Subject: **Response to comments CUP230002 review by EVMWD.**

EVMWD Comments/Corrections (11/17/25 Email):

Figure 1 Vicinity to Canyon Lake

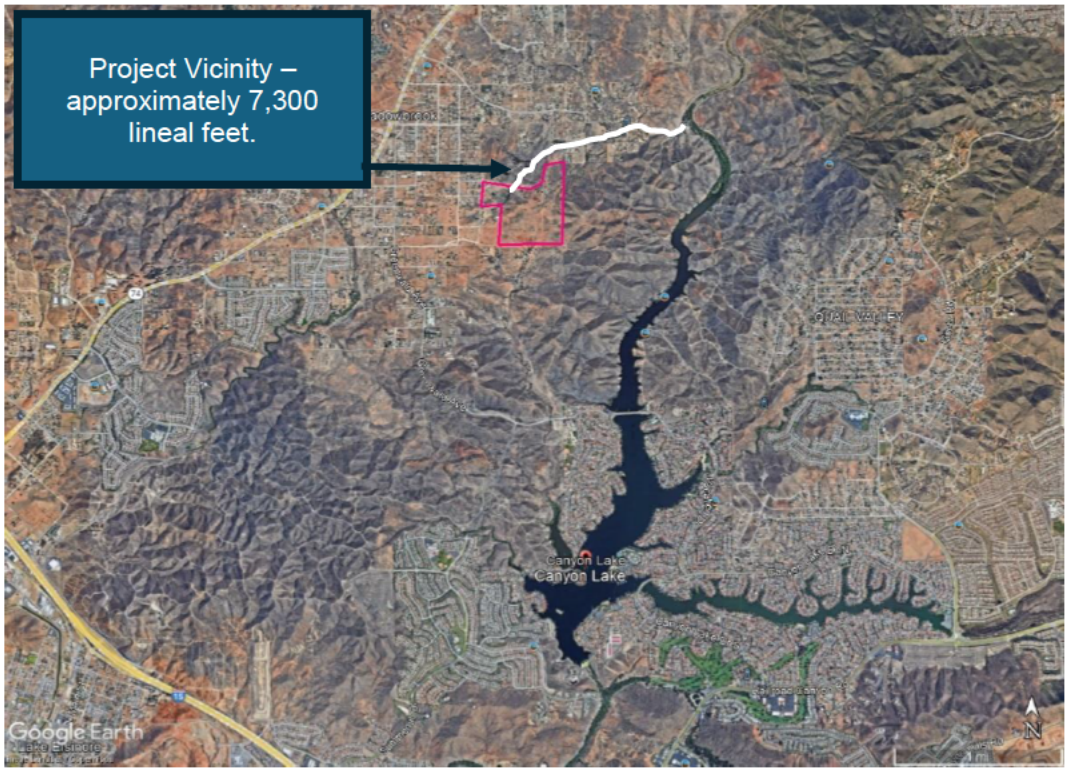
1. **Canyon Lake must be identified as a receiving water body, with designated beneficial uses including Municipal Drinking Water and full contact recreational uses.**

Response: The proposed Crescent Garden Cemetery project (Project) being within the watershed of Canyon Lake will be added to discussions in Initial Study (IS) for CUP23002. The IS will reference in the project description, hydrology report, and Water Quality Management Plan (WQMP).

The Project is more than 7,300 lineal feet west of the water body north of Canyon Lake. It is approximately 1.78 miles to the north of the nearest water body of Canyon Lake called Jump Lagoon, as shown in Figure 1- Vicinity to Canyon Lake.

Figure 2 Flood Plain Exhibit

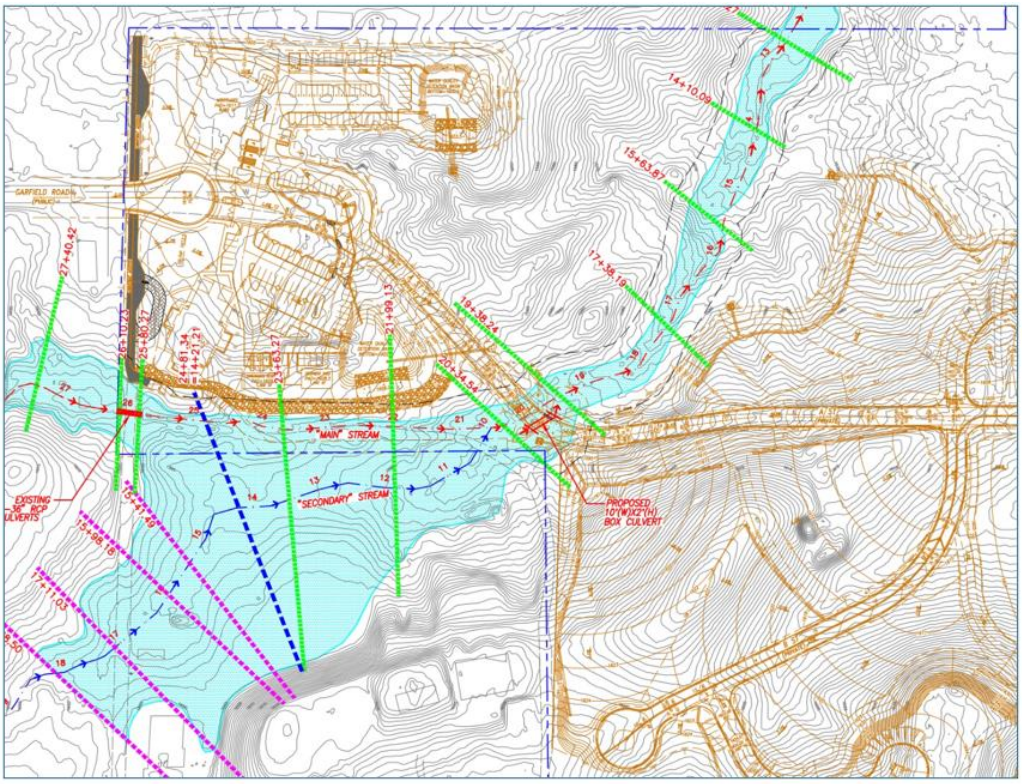
2. **Setback distances to adjacent streams (WOTUS) that drain to Canyon Lake must be specified.**

Response: Project burial site pads are beyond the 25-foot setback from the 100-year floodplain boundaries as required for flood protection. Refer to Figure 2, Floodplain Exhibit .

Figure 3 Typical BMP Basin

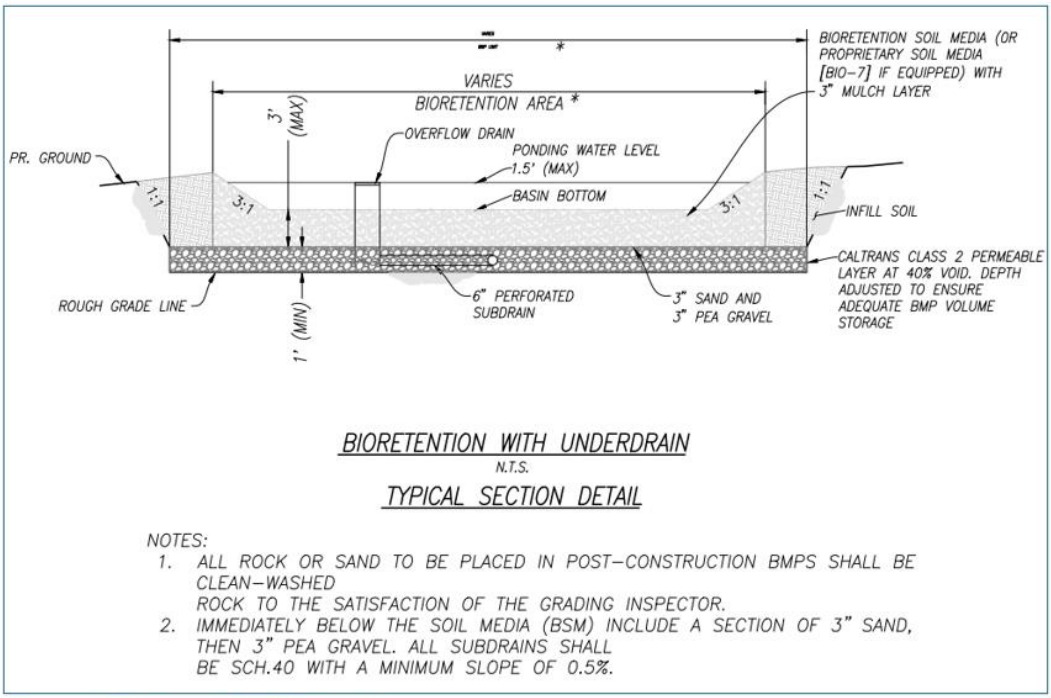
3. **BMPs must be specified for addressing overflow and discharges from onsite treatment ponds to adjacent WOTUS, streams that drain to Canyon Lake.**

Response: Refer to Preliminary Water Quality Management Plan Crescent Gardens revised June 18, 2024. Please note that there are no "on site treatment ponds" in this project. There are four (4) water quality/detention basins that are BMPs for treatment of stormwater runoff from impervious areas, in conformance to County's Low Impact Development (LID) requirements for mitigation of water quality and hydromodification. Please refer to Figure 3 Typical BMP Basin cross-section.

Figure 4 Burial Plot Detail

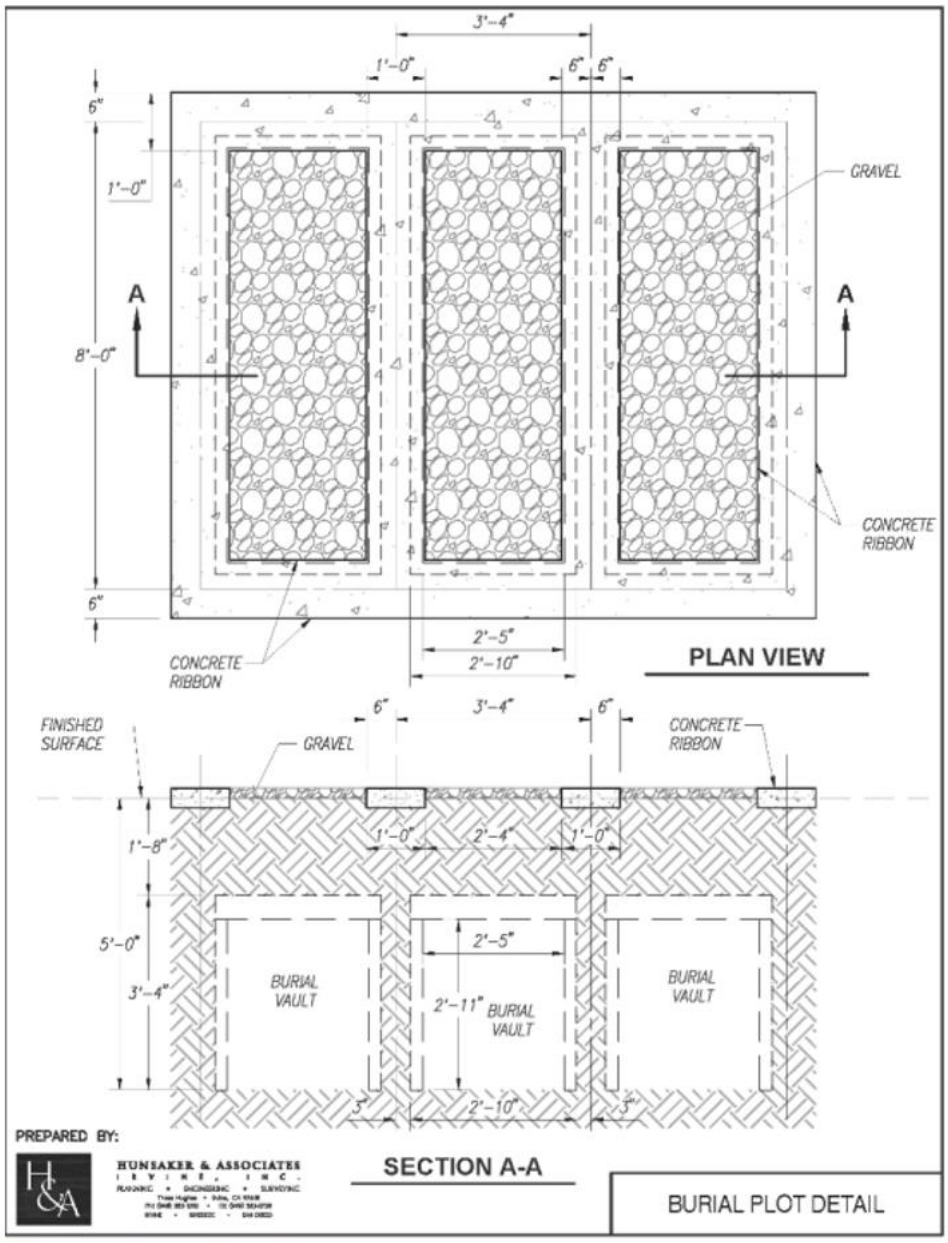
4. **BMPs must be specified to address cemetery/grave sites Leachate (due to decomposition of buried bodies) from influencing adjacent WOTUS/streams that drain to Canyon Lake.**

Response: The gravesites will be approximately five feet below finish ground surface (including regulatory 18 “inches minimum topsoil). This shallow depth ensures that the grave does not impact the local water table. The water table in this area is approximately 147 feet below ground surface. (Leighton Geology Report, 5/31/2024) Refer to Figure 4 Typical Burial Section and Figure 5 from Initial Study.

- No embalming.
- No chemical like formaldehyde are used in ceremonial body washing and preparation.
- No casket. The deceased body is placed on ground in a cotton cloth shroud. This allows for a natural decomposition process of a human body.
- A liner is used in place of a vault; this ensures that body is placed on ground soil within the confinement of the biodegradable shroud.
